Planning Comments and Responses: 3328 Verdun Ave
Re-submittal Round #2

Comments Requesting Additional Information:

Comments from Cannon Design:

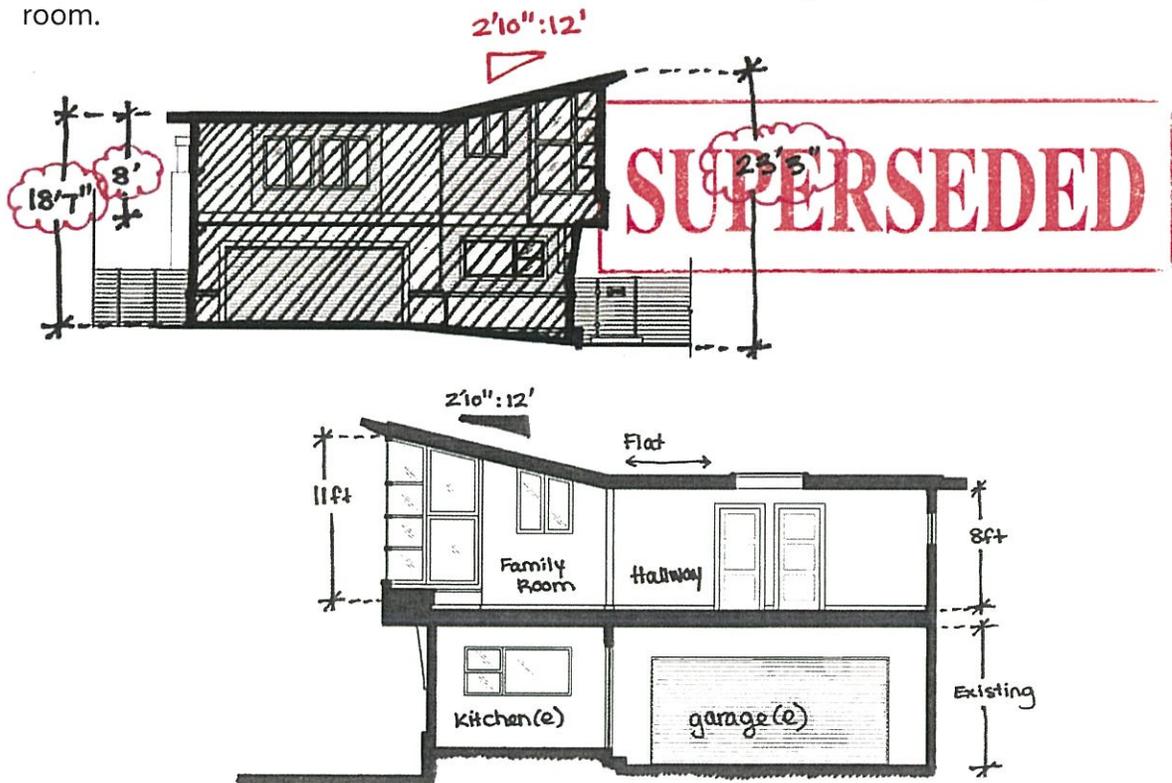
1. The front facade has a substantial amount of two story wall surfaces relative to those in the immediate neighborhood.

Suggestion: "the addition of belt trim at the second floor line, a projection of the bedrooms over the first floor facade, and the enhancement of the bay window at the bedrooms as shown in the illustration [...] in addition, substantially recessing the garage door would add to the visual depth of the facade."

Response: We have added the belt trim and the projection of the bedrooms over the first floor facade. The bay window of the bedroom is now a boxed element with a limited extrusion due to setback requirements. The garage door being moved is not a part of our scope of work. However, since we will be stucco-ing the front facade of the house, the door will have a visual depth as requested.

- flat roof
8 ft plate
- 2nd floor extrusion
over garage
- "belt" trim
between floors
- new stucco
around garage

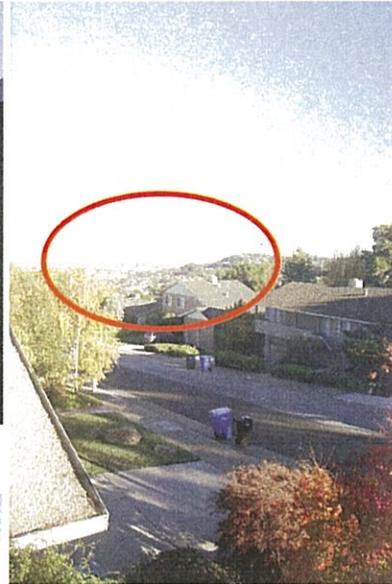
2. The second floor addition will block some views from the second floor main living spaces of the house immediately adjacent uphill of the site.

Suggestion: "Further mitigation could be achieved by the utilization of a flat second floor roof with the integration of a popup roof element over the central media area of the Family Room as shown on the floor plan and the front elevation illustrations [...]."

Response: We have changed the roof to utilize this technique, but have opted to leave the whole family room with the pop-up roof element. We believe it is critical for the interior architecture of the space to have a continuous ceiling plane. The flat roof offers relief to the uphill neighbor's views and allow her to continue to look over the property. This has required, as stated by Cannon also, that the plate is returned to 8 ft. The gain is that the addition is more cohesive with the neighborhood, and that it does not increase in height until the family room.

PRIMARY LIVING ROOM VIEW

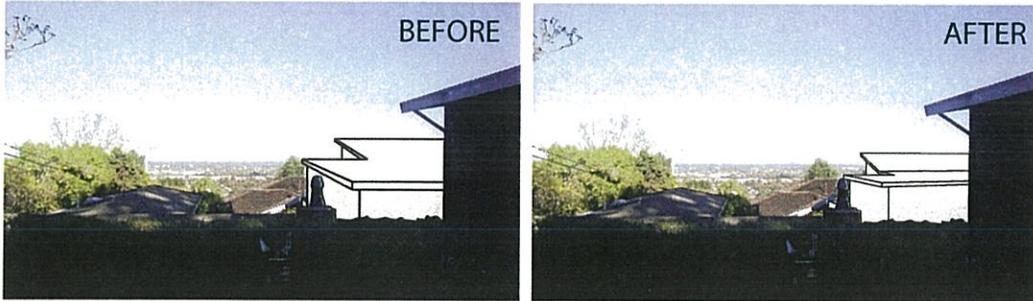
The following diagrams show the views of the uphill neighbor with the addition. We have included the views as seen with our initial planning submission (before), and as they have altered for this re-submittal to planning with the compromises and revisions we made (after).

The addition is built to the front of the property as much as possible at the request of the uphill neighbor, who didn't want her primary view to be affected. While this means her bedroom view is partially blocked, we have striven to maintain as much of it as possible, and the light and air she receives in that room is not affected.

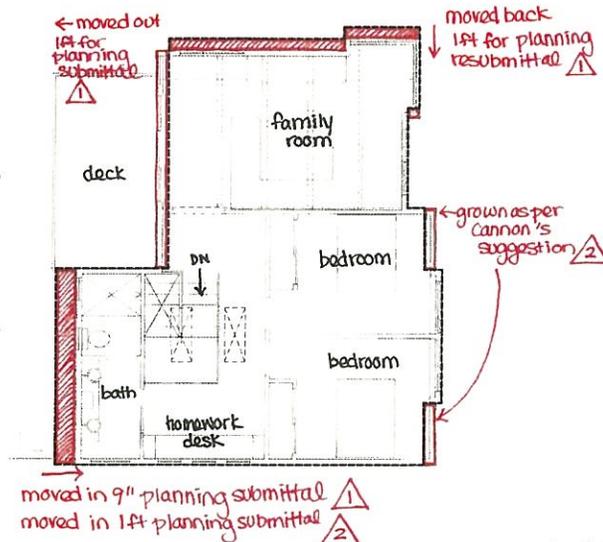
16. Can the second story addition/roofline be lowered (over the family room area) and the second story building line pulled back further (toward the street)?

As per Cannon's comments, the roofline is lowered to an 8 ft plate, flat roof, except for the family room area. The diagram below shows the view from the neighbor's bedroom view, the only view that is negatively affected by the addition. This shows that the major view is to the left of the family room. The downhill existing trees prevent the family room from causing further view mitigation even with the popup roof, so lowering the roof in this area is not necessary to maintain views.

The building line is pulled forward 1 ft at the bathroom, to offer further relief to the bedroom window. Likewise, the whole of the addition is pulled forward 1 ft per Cannon's response, in a style which is consistent with the fabric of the neighborhood. This diagram shows the old and new placement of this building line.

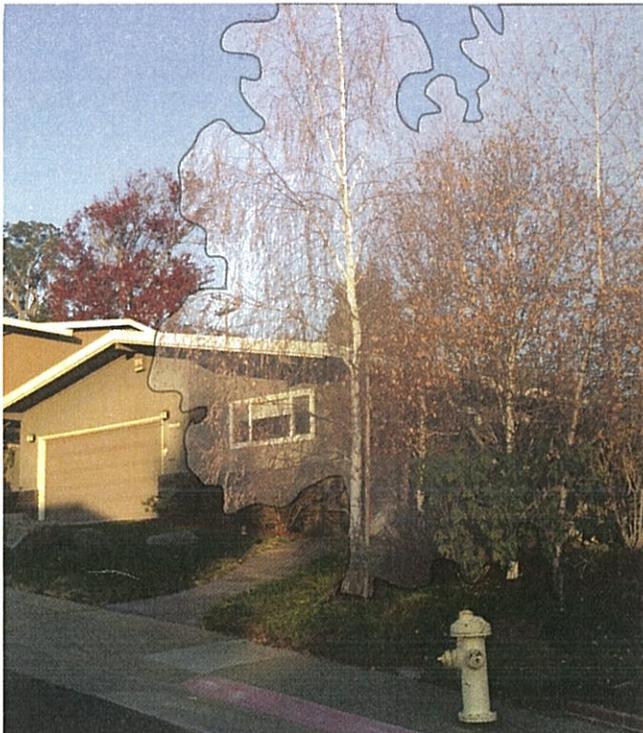
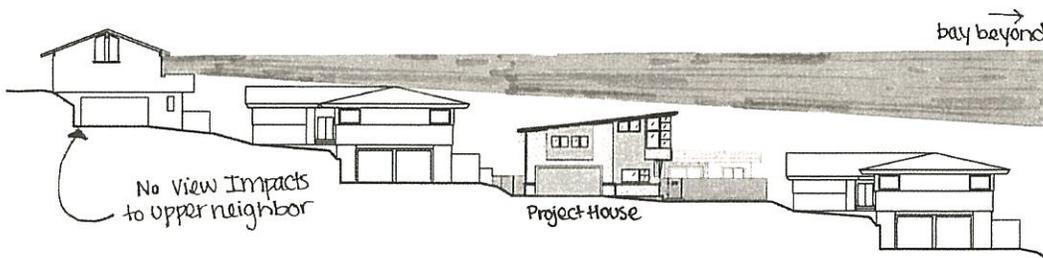
8. Lowering the Eave Lines. To the greatest extent possible lower the eave lines to minimize view impacts and reduce the apparent mass of the two-story building walls (see attached page 19 of the Design Guidelines).

By lowering the eave height by 1 ft, we've mitigated concerns from the upper uphill neighbor. Their view is not affected by the addition at all. And extreme measures have been taken to not affect the view as much as possible of the immediate uphill neighbor. This diagram shows the views of the upper uphill neighbor.

One of the helpful factors to reduce apparent mass is the current tree cover that exists on the project site, downhill of the home. This tree coverage, which we are willing to add to in order to make denser, prevents a direct view at the addition when coming up the hill, which reduces the apparent mass significantly from that direction. This photo, taken in winter when the foliage is least effective, shows that the trees directly block views of the corner where the highest eaves will be.

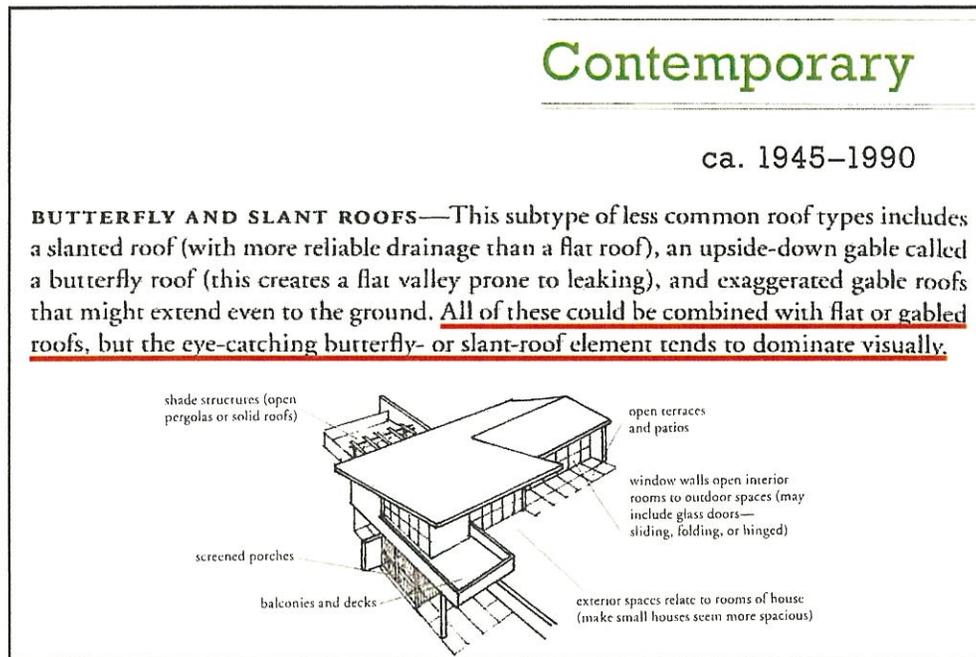
9. Roof Design Compatibility: The proposed roof form for the second story addition is not compatible with the roof form of the existing structure. The proposed project illustrates the attached “what-not-to-do” sketch by using two different roof forms on page 21 of the City’s Design Guidelines.

The proposed roof form is not identical to the existing roof, but is an acceptable solution and is compatible with the contemporary ranch style, according to the Second Edition of the Field Guide to American Houses, quoted below with their relating diagram:

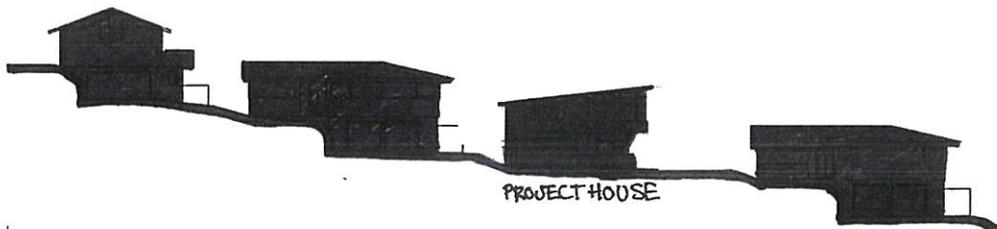
10. Wall Articulation: The addition appears massive from the street with overhanging, cantilevered portions, and two story walls with little to no wall articulation on the facade. See page 23 of the City's Design Guidelines for suggestions to avoid long tall walls.

The diagram to the left show the articulation of the facade from the first to the second level. The rendering show how material and cantilever is used to create articulation.

The diagram below shows the comparable mass between the project house and the neighbor houses as viewed from the street. This mass is further visually decreased from the downhill side because of the trees that are on the project property, as you can see in response to #8 about views.

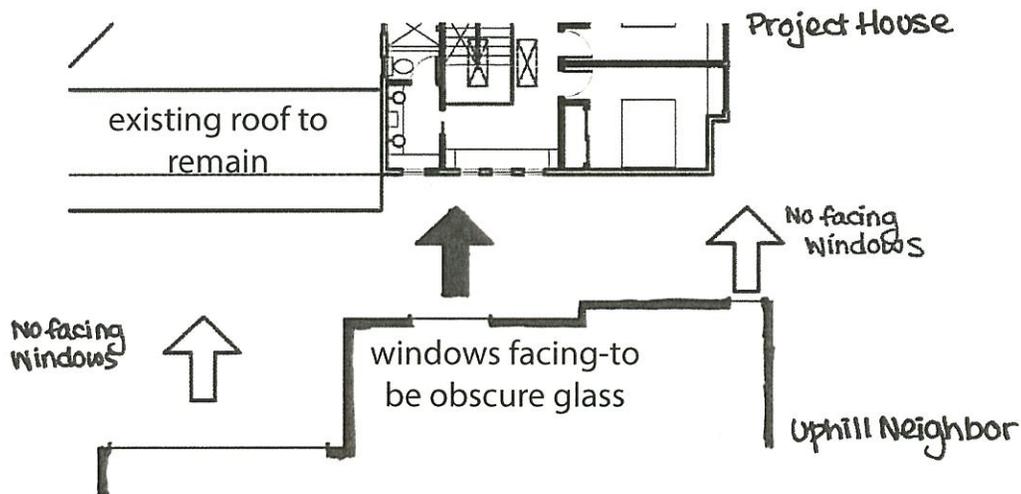
11. Privacy: Are planned windows aligned with the neighboring windows or offset? Please provide an exhibit similar to the example in the Design Guidelines on page 24.

View Diagrams have shown that the neighbor's bedroom window can see down into the proposed bathroom and hallway windows, so these windows have been changed to be obscure clerestory windows, which will be better for the privacy of the children's spaces.

The existing roof is maintained in front of her main view, the large windows in her living room.

The views from her guest bedroom is directed to the front corner of the property, missing the addition and maintaining her view across the street and down towards the bay.

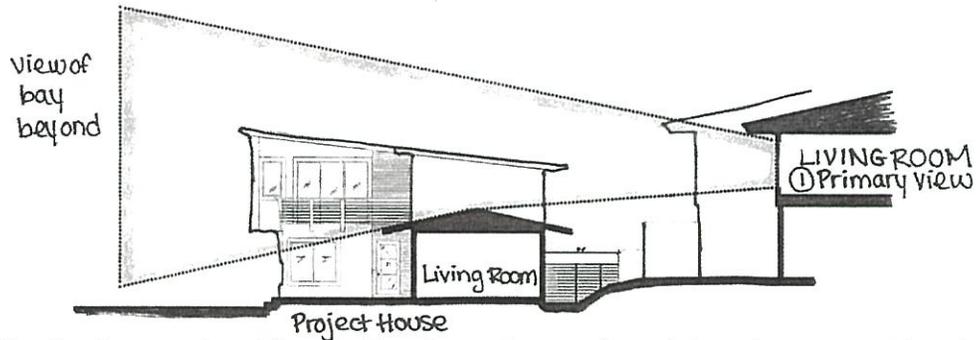
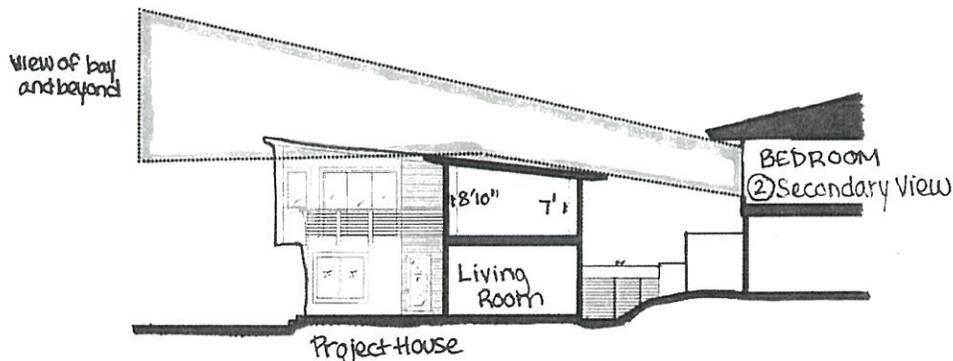
12. View Impacts: Label and minimize interior ceiling heights on the building section. Pursuant to the City's Design Guidelines a method of minimizing view impacts is to lower roof plate heights. See page 27 of the attached Design Guidelines.

As shown in the second diagram, the interior ceiling height is 7' at the uphill corner, in order to minimize the effect of the addition on the view of the uphill neighbor. The uphill neighbor, has three views she wishes to maintain:

1) Her main view, is from her large living room windows. The addition has been moved forward on the house to avoid impacting this view at all, and her line of sight goes over the existing living room roof.

2) Her bedroom view. The roof has been lowered, and the plate set to 7' at the close side, so as to maintain as much of this view as possible. The roof has also been cut back, uncovering the porch. The porch is still private to the neighbor, but her view is improved because of that roof element being reduced.

secondary, bedroom view of uphill neighbor

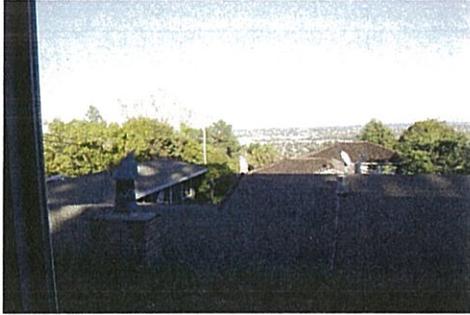
12. continued... The photos above show the placement of the addition as seen from the uphill neighbor. The uphill neighbor's house looks over the whole project house, so in deciding on a placement for the addition, it was discussed with her and she preferred her panoramic living room view to be maintained, meaning the addition would have to be in front of her bedroom.

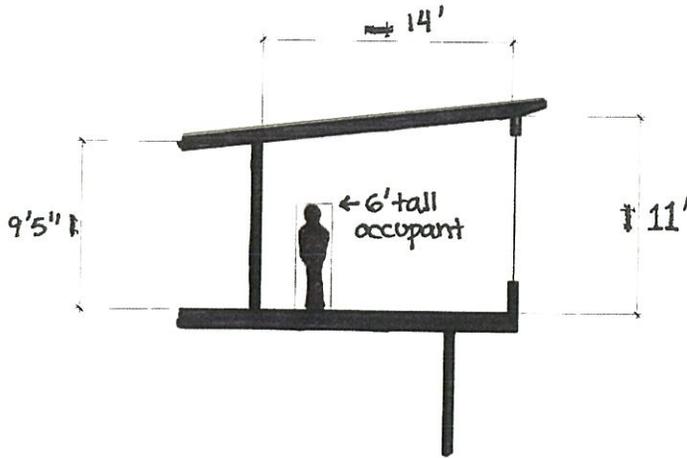
13. Roof Design Massing: The proposed roof design creates large volumes of living areas beneath the "up-slope" of the roofline which contributes negatively to the mass and view impacts.

This diagram is of the family room space under the highest point of the "up-slope." At this point the ceiling height is 11' tall. This is not a large volume as a public space, and has been lowered 1 ft to help the eave height be as low as possible.

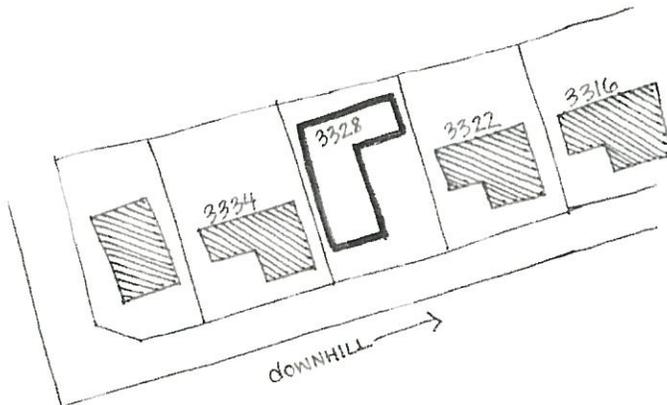
14. Home additions on sloping lots should step with the slope of the lot to avoid tall walls.

The diagram below shows that the existing project house does not step with the slope as the other homes on the street do. With this in mind, the series of diagrams to the right illustrate the reasons the addition was chosen to be where it is, and why putting it either on the rear of the house or in the yard isn't a good choice.

Addition over rear of house: blocks neighbor's main view, overlooks downhill neighbor's windows and yard.

Addition over yard: Doesn't conform to site coverage limits, crowds downhill neighbor, creates unfavorable view from uphill (large expanses of roof).

Addition over front of house: preserves neighbor's main views, matches neighborhood pattern of second story over garage, doesn't increase site coverage.
